Town of Brunswick

Committee:	Staff Review Committee		
Date of Meeting:	12/10/2025	Time:	10:00 AM
Minutes Prepared By:	Susan Karnes, Administrative Floater	Location:	Town Hall, Council Chambers / Zoom
1. Purpose of Meeting (<i>Weekly meeting, Training, Workshop, etc....</i>)			
Weekly meeting

3. Meeting Agenda
<p>1. Case No. 25-059 – MaineHealth Mid Coast Cancer Center Renovation: The Staff Review Committee will review and make a recommendation to the Planning Board on a Site Plan Amendment application submitted by Pine Tree Engineering on behalf of the property owner, Mid Coast Health Services, for two one-story additions and the renovation of the existing building and parking area. The subject property is located at 81 Medical Center Drive (Map 45, Lot 32, 32-1) and within the Growth Mixed-Use 8 (GM8) Zoning District, and the Shoreland Protection Overlay (SPO), Shoreland Protection Overlay – Stream Protection (SPO-SP), Shoreland Protection Overlay – Resource Protection (SPO-RP), Rural Protection Stormwater Management Overlay (RPSMO), Flood Protection Overlay (FPO), Wetland Protection Overlay (WPO), and Cook’s Corner Overlay (CCO) subdistricts. The proposed location of developmen

4 PHARM EAST
A4.01 3/16" = 1'-0"

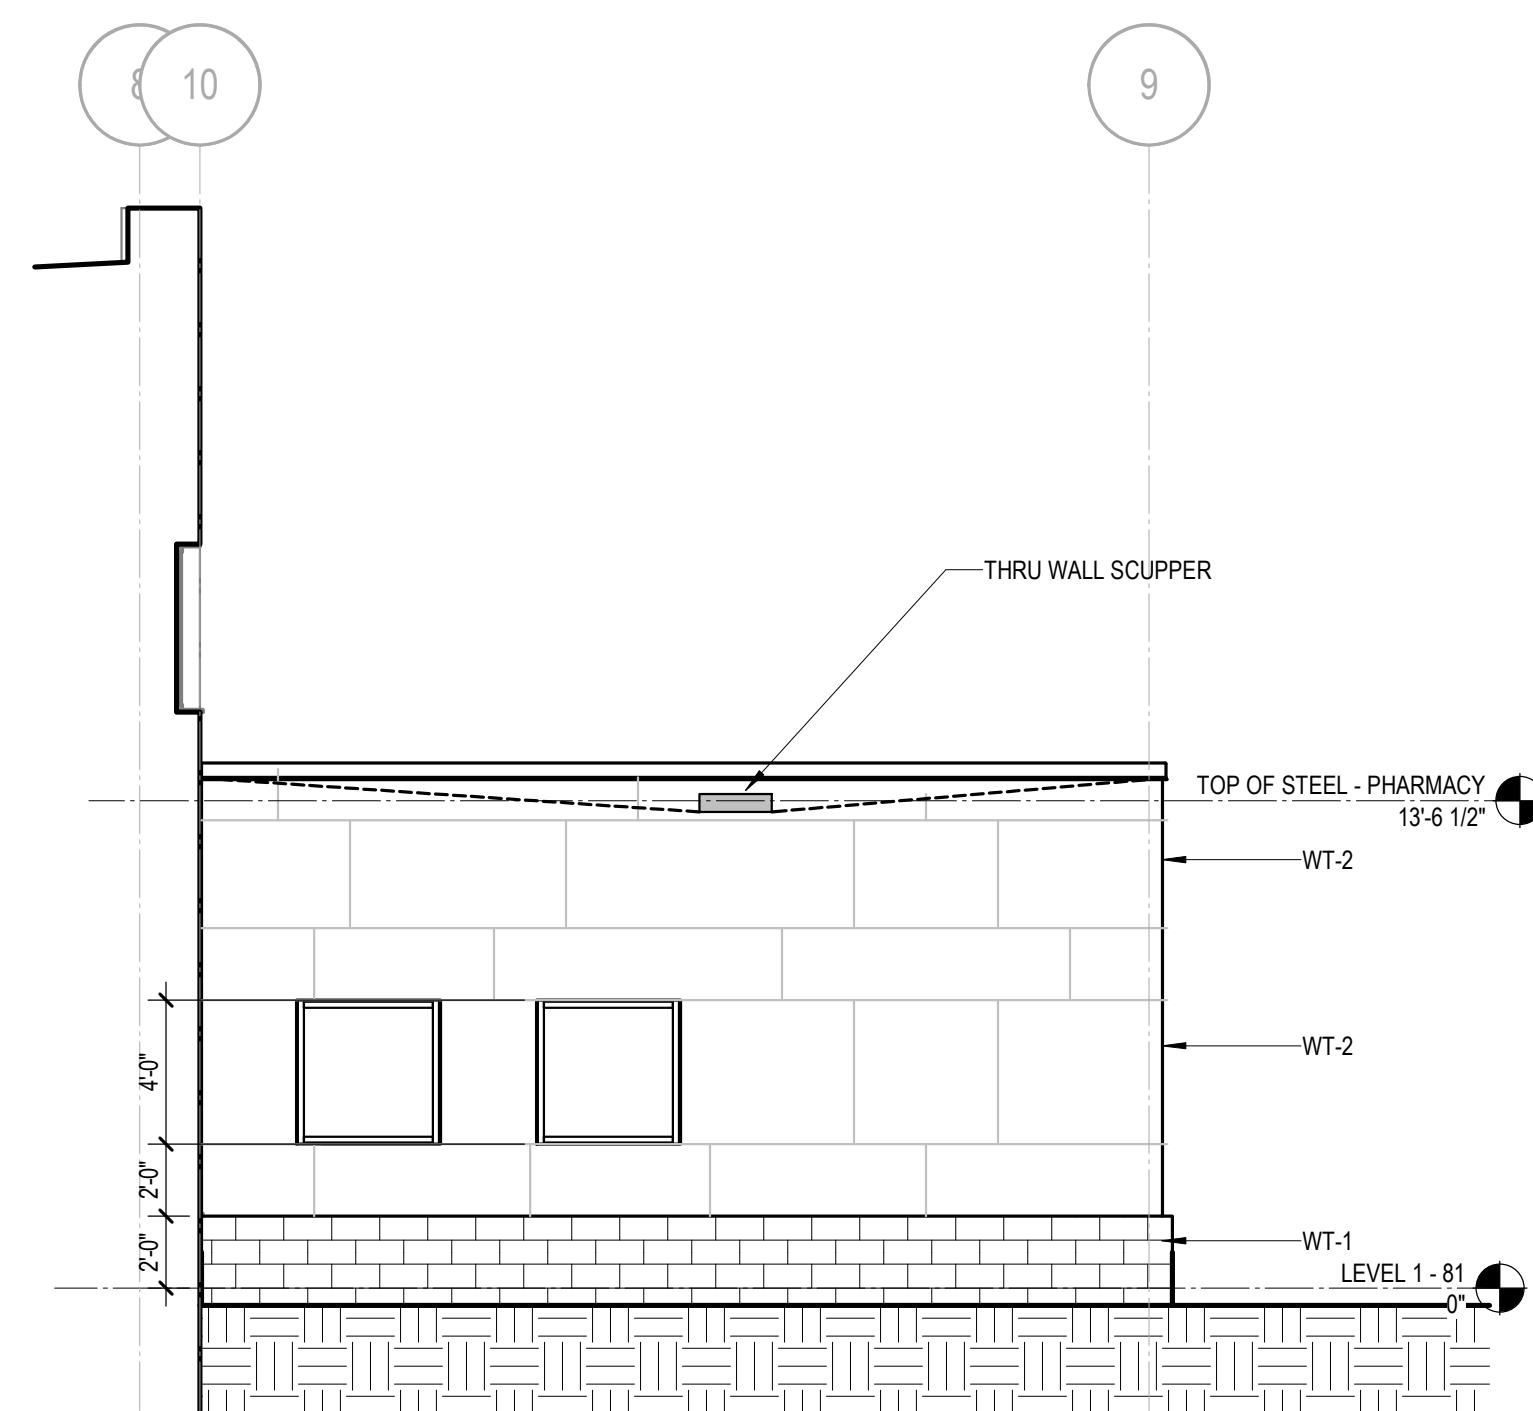
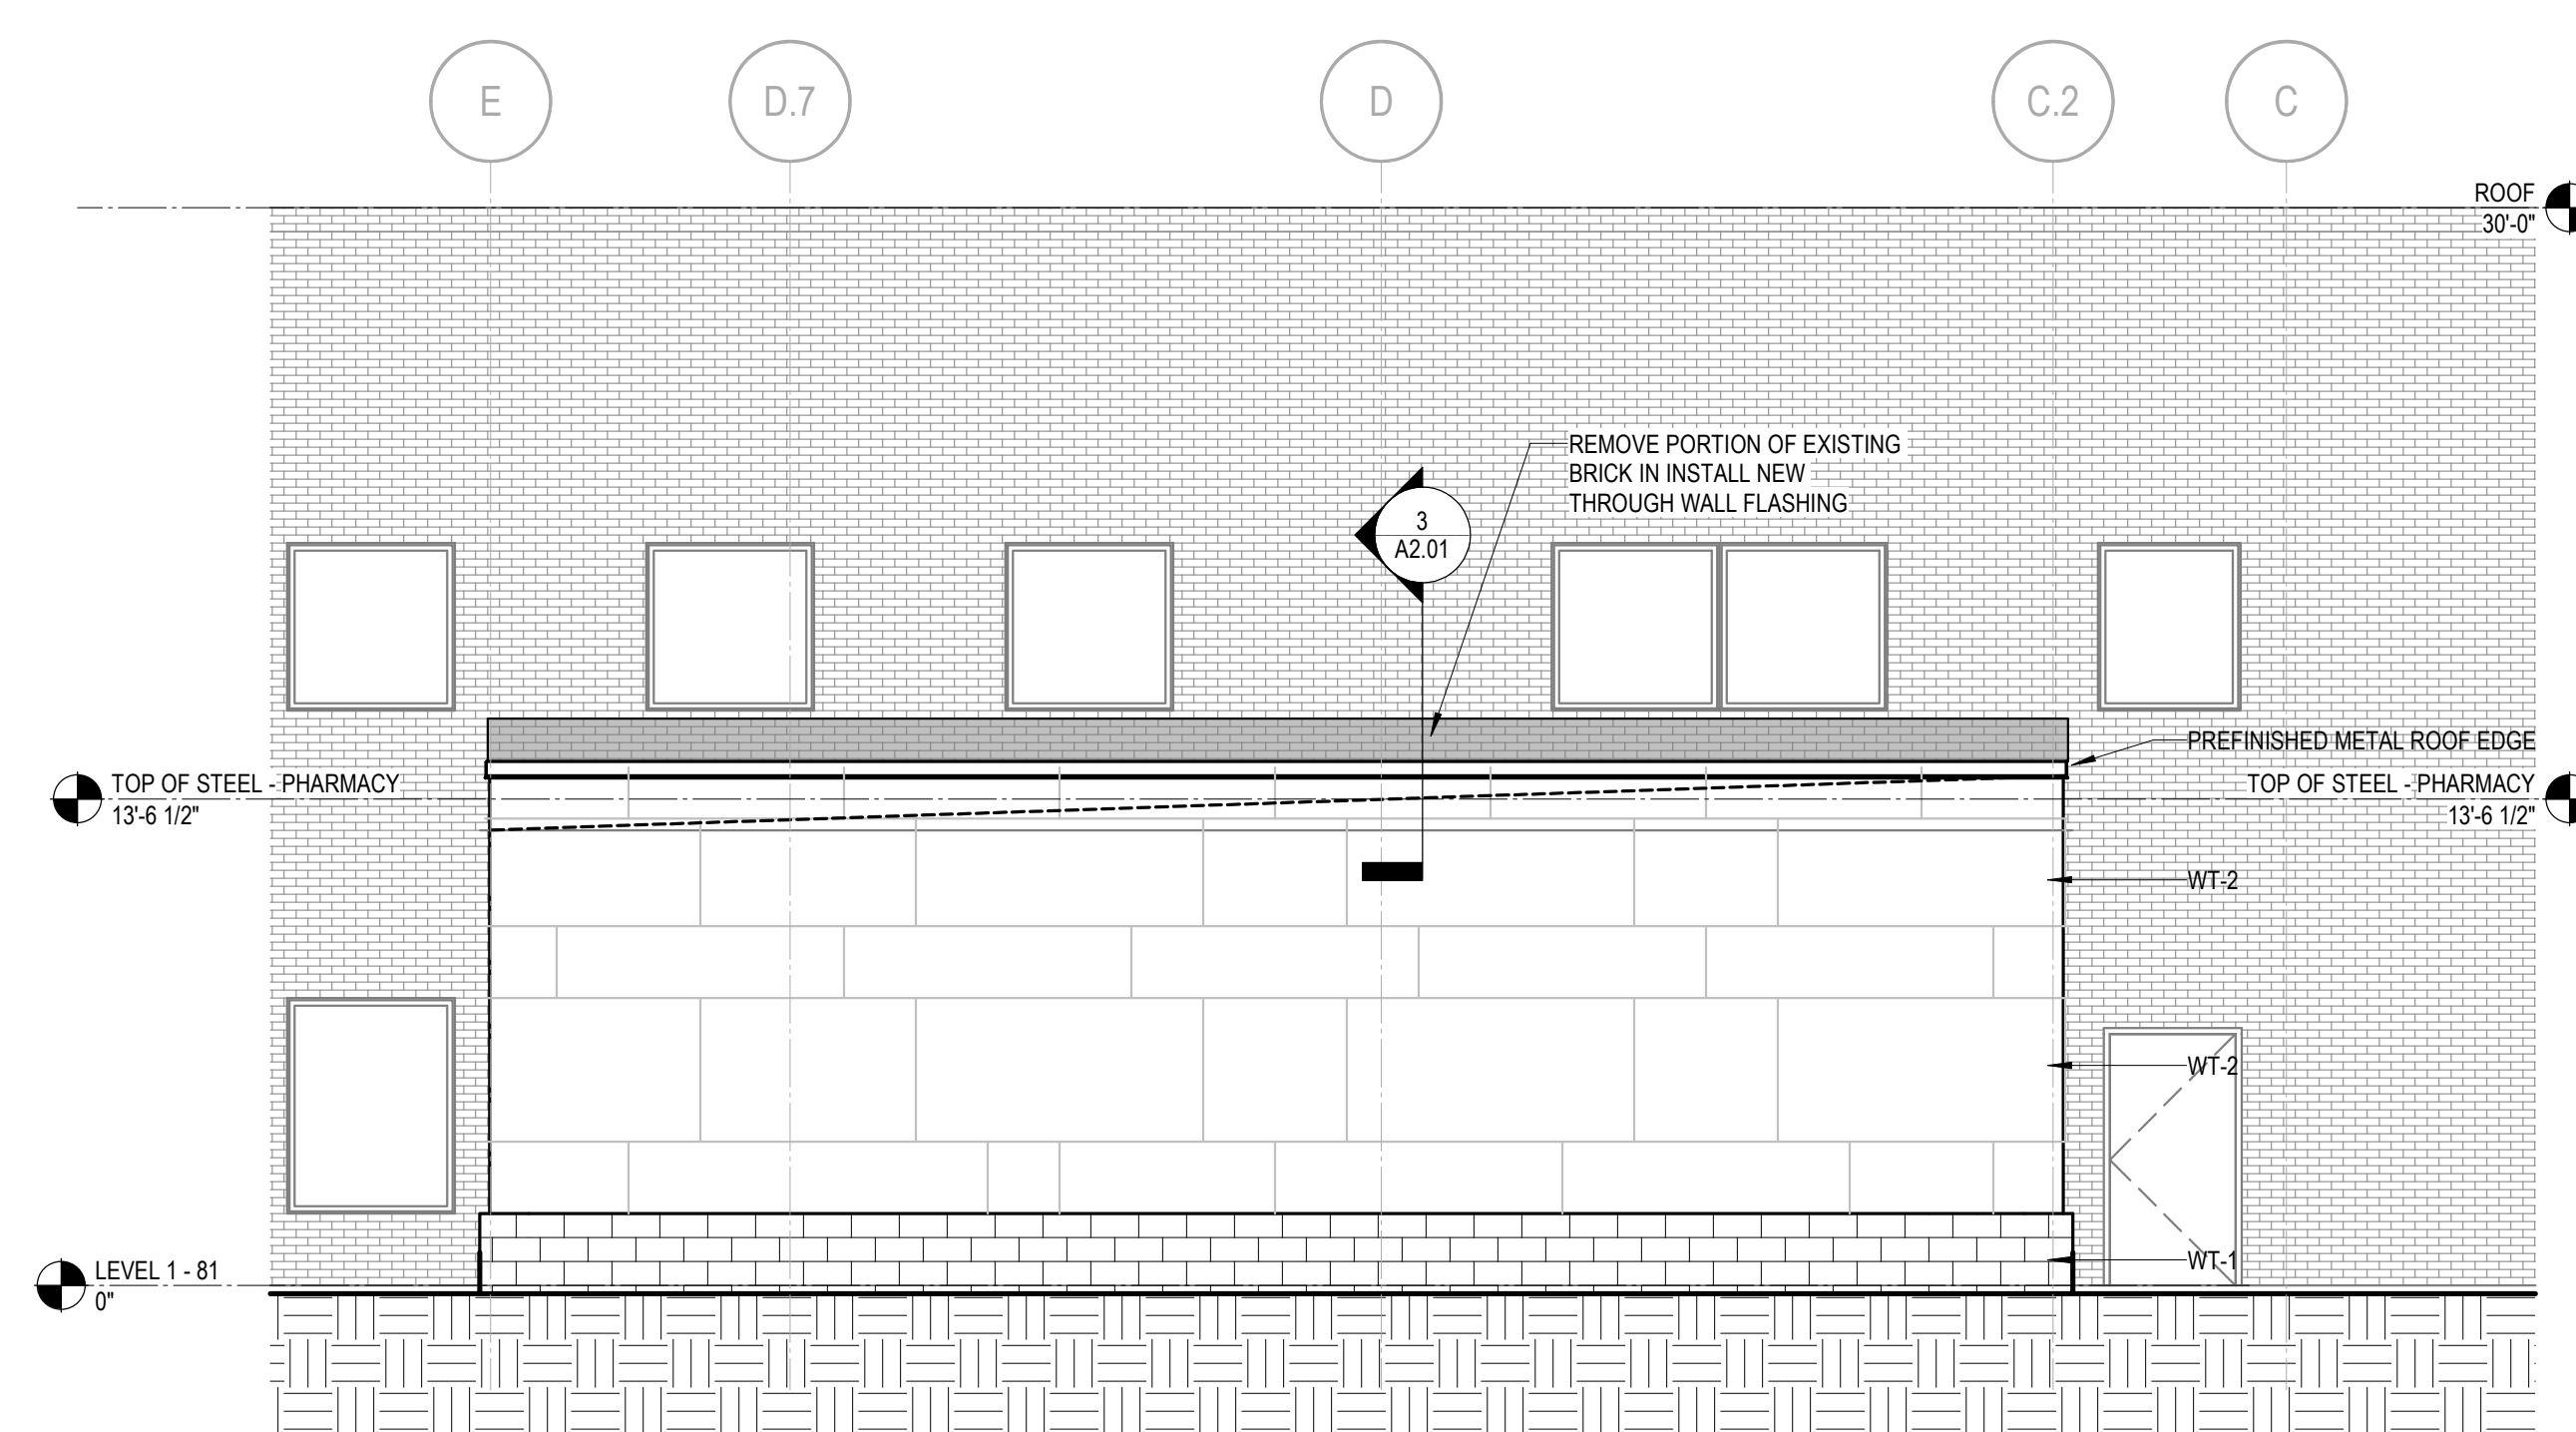
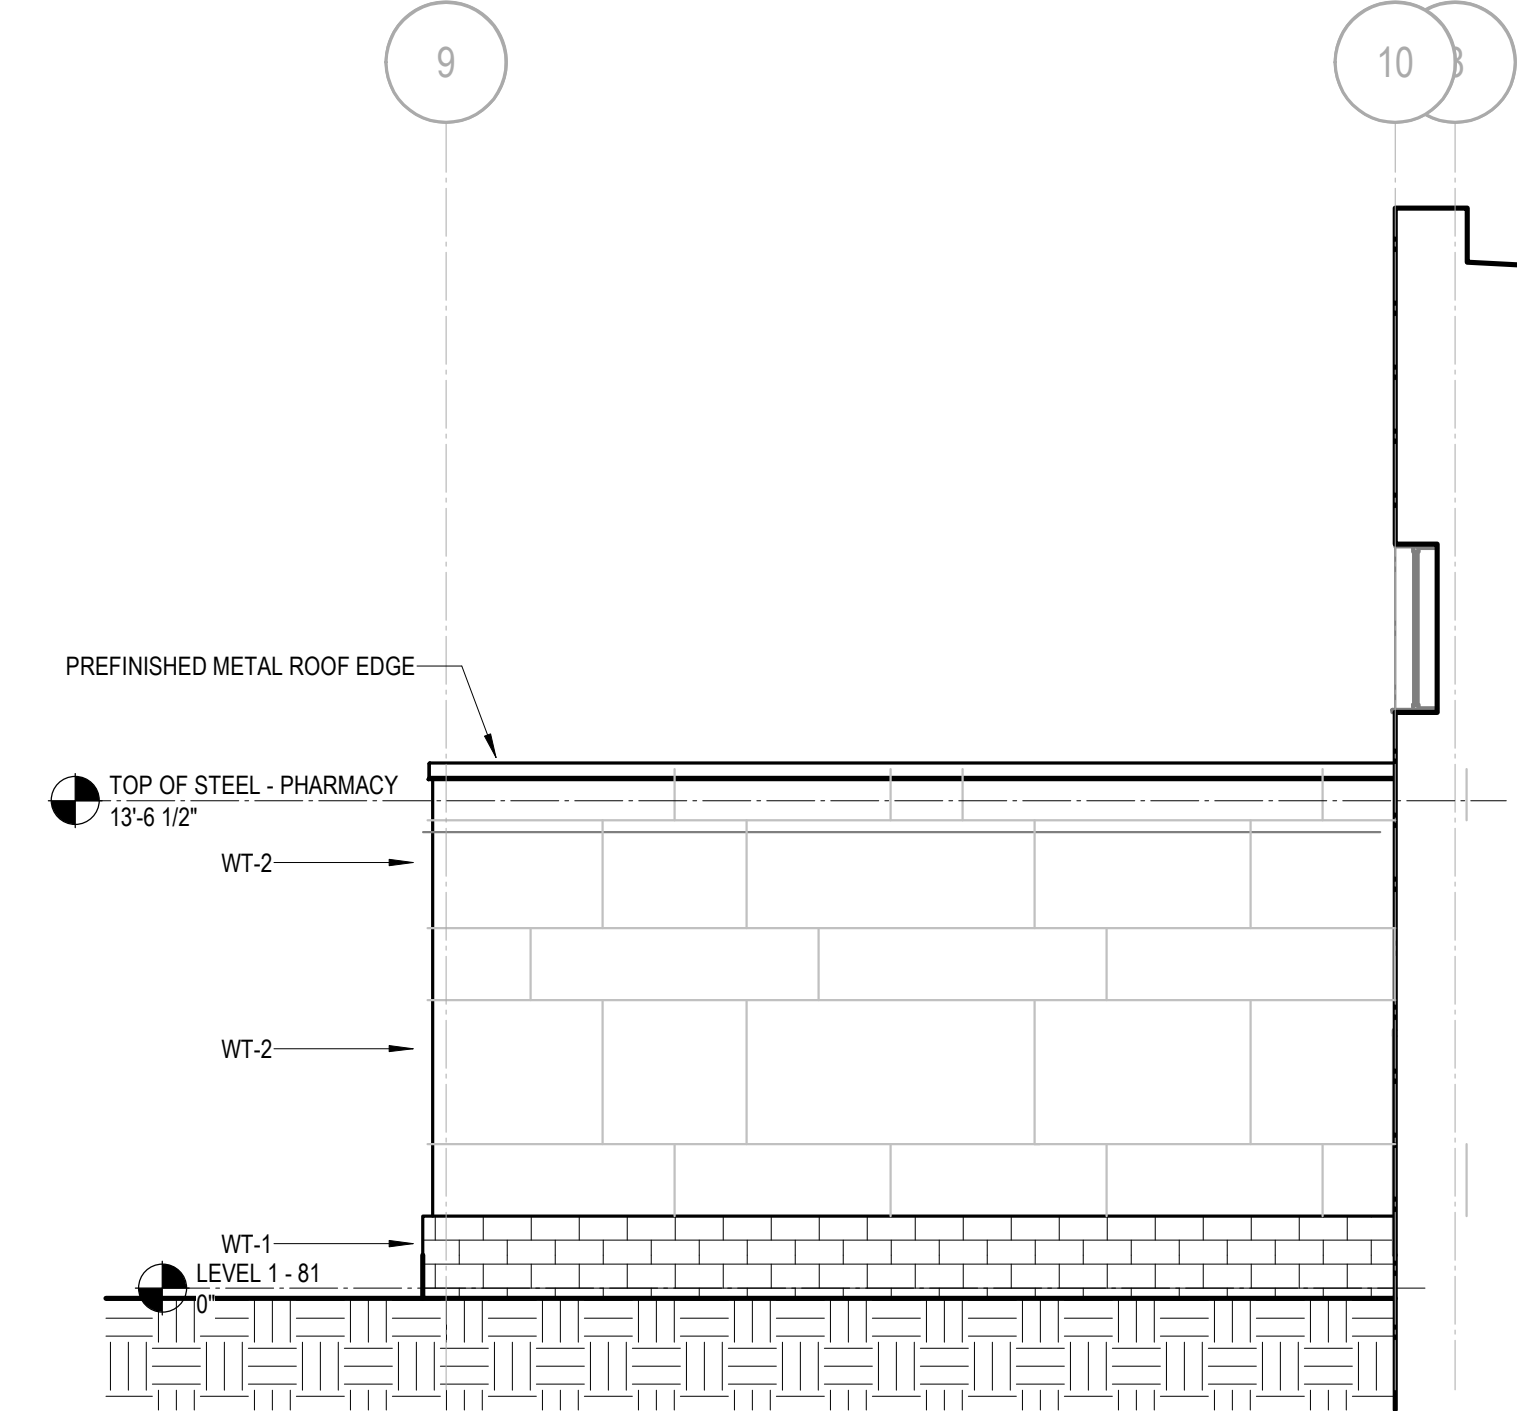
Chrissy Adamowicz: Did you have a chance to look at the Cook's Corner design standards when you were developing this? Because they do apply. And we reviewed Section 3.4, where it talks about the facade requirements and it doesn't quite meet the requirements. The requirements ask for windows and a broken-up facade. And we were looking at it and we understand that it's not like a really very public facing building. It's not like the full building, but it does apply to additions. But had you considered windows in any parts of the buildings and also maybe vegetation to break it up? The standards talk about a variety of ways to break it up.

3.4 J Windowless circumstances says, "buildings without windows, i.e. a computer, a server building or self-storage buildings, shall incorporate a change in scale and siding materials instead of windows to create a sense of rhythm and cadence to create human scale. These material scale changes shall be demonstrably compatible with the scale and cadence of adjacent building facade treatments". The LINAC part of the building is towards the back, but the pharmacy faces a parking lot, so that is a little bit human facing.

3. Add ornamental grass along parking lot side of pharmacy, near bollards	See Section B-B on AS3.00 Civil Details
Architecture Comments	
4. Review Cooks Corner Design Standards, specifically Section 3.4 Façade Requirements, and within 3.4.j.	See Exhibit 8: Cook's Corner Design Standards Narrative.
Engineering Comments

The two additions to 81 medical center drive are secondary facades according to the definition in Section 3.4 Façade Requirements item C.

The design of these additions take into account the scale, materials and colors of the existing building, by complementing these colors and materials rather than attempting to copy directly as it is difficult to match brick and precast that have weathered for 18 years.
